Application 09/925,059

Reply to Office Action of May 25, 2005

AMENDMENTS TO THE DRAWINGS:

Application 09/925,059
 August 25, 2005
 Reply to Office Action of May 25, 2005
 Annotated Sheet Showing Changes

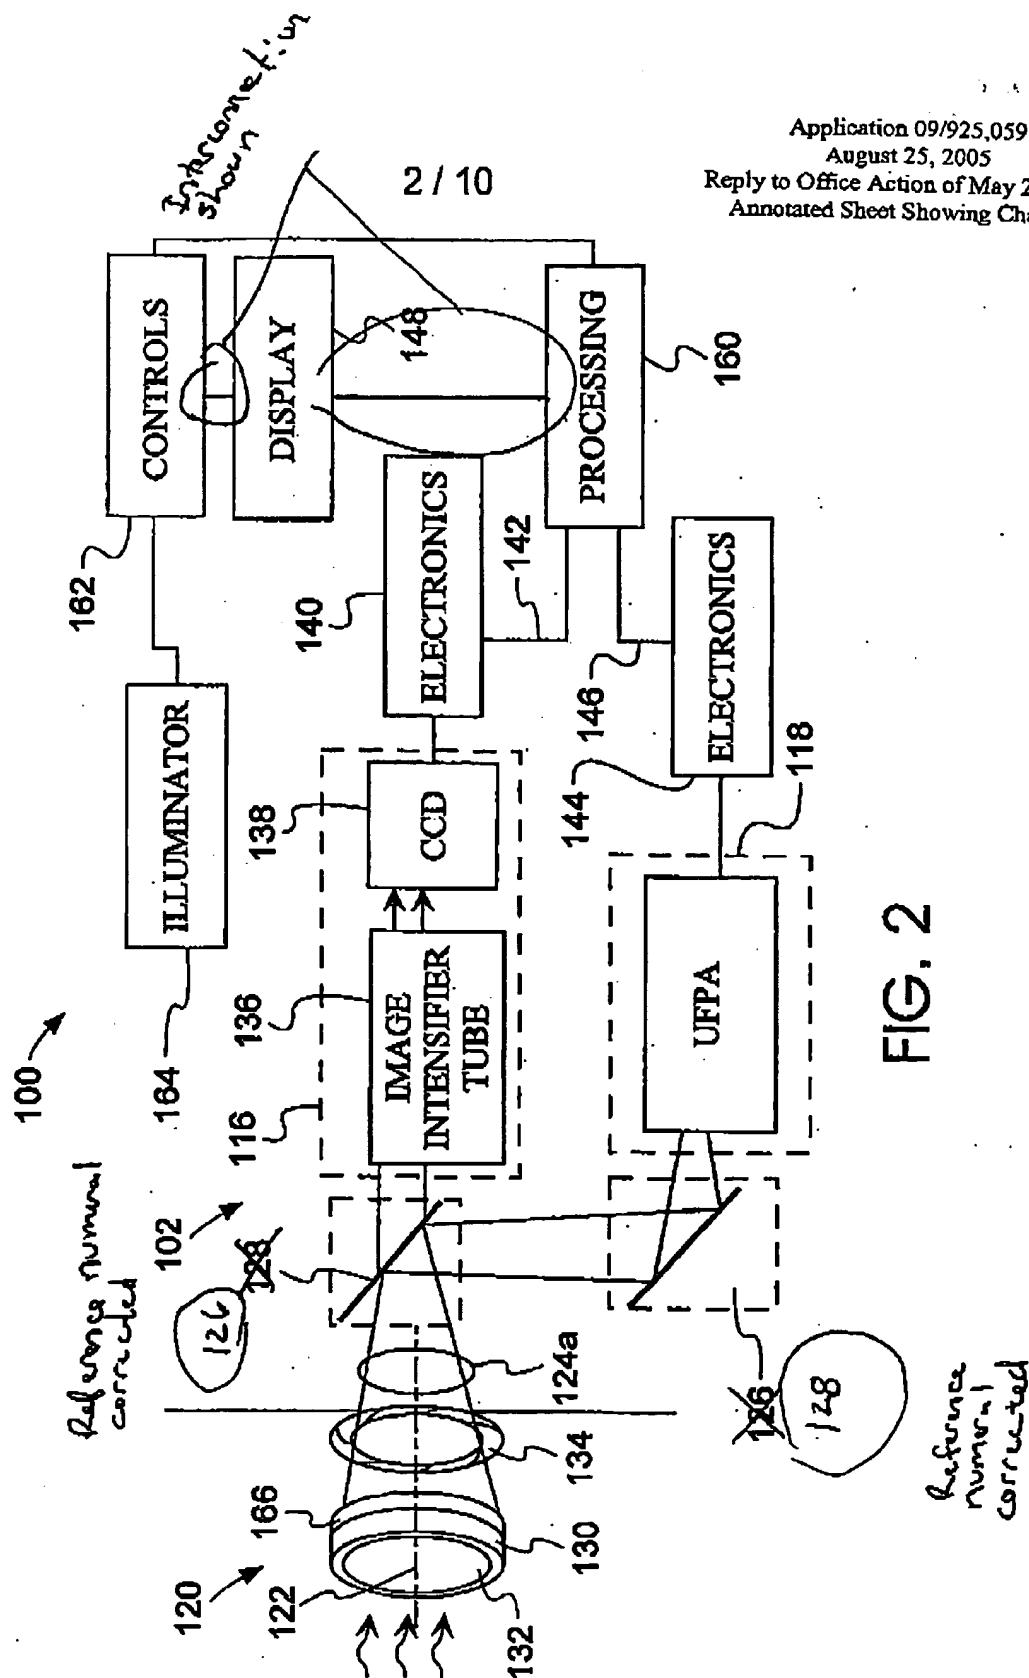
The first attached sheet of drawings includes changes to Fig. 2. This sheet, which includes Fig. 2, replaces the original sheet including Fig. 2. In Figure 2, a line connecting the display 148 to the controls and processing was omitted and has been added. The correction to the drawing is fully supported by the specification and the applicant believes that no new matter has been added.

FIG. 3A

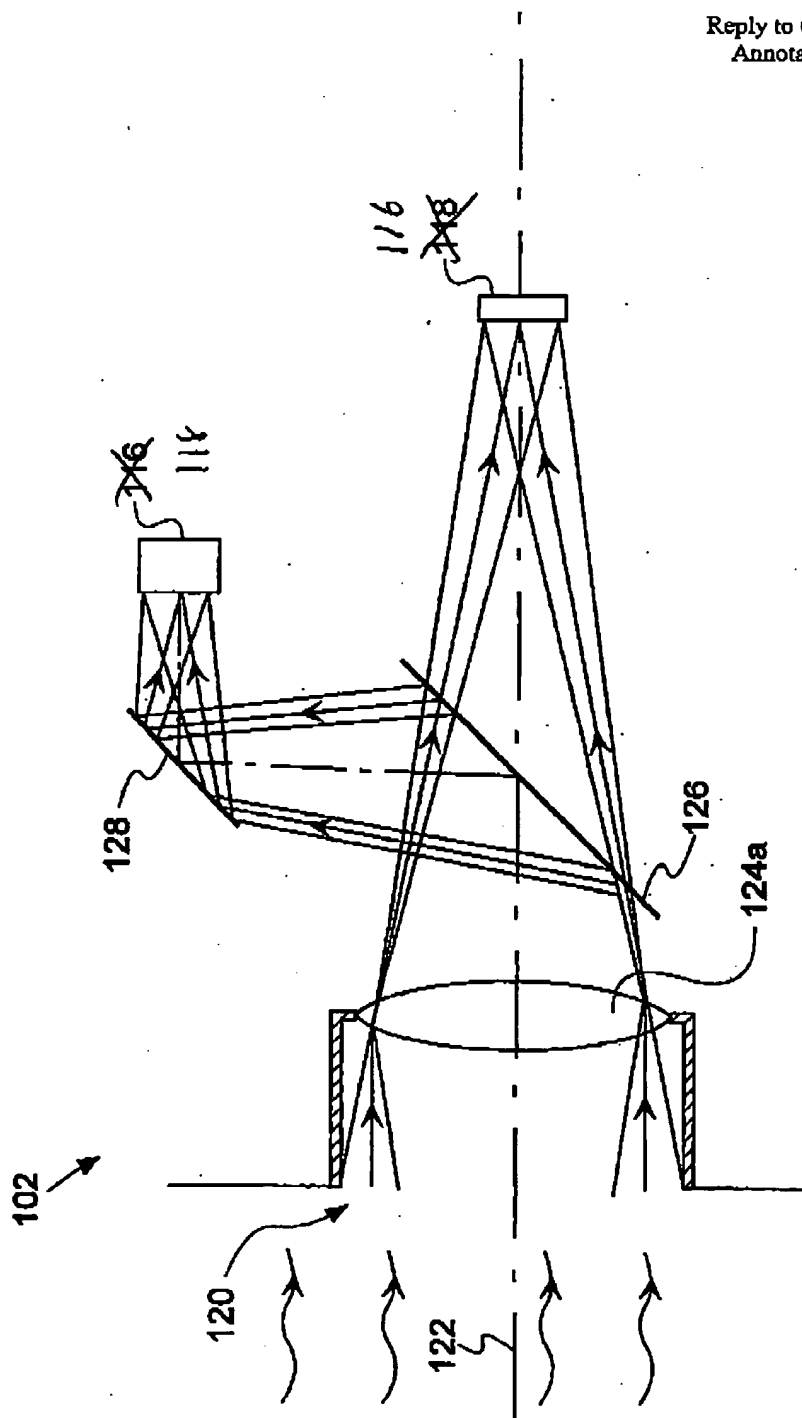
The second attached sheet of drawings includes changes to Fig. 3A. This sheet, which includes Fig. 3A, replaces the original sheet including Fig. 3A. In Figure 3A, reference numbers 116 and 118 were inadvertently transposed. The correction to the drawing is fully supported by the specification and the applicant believes that no new matter has been added.
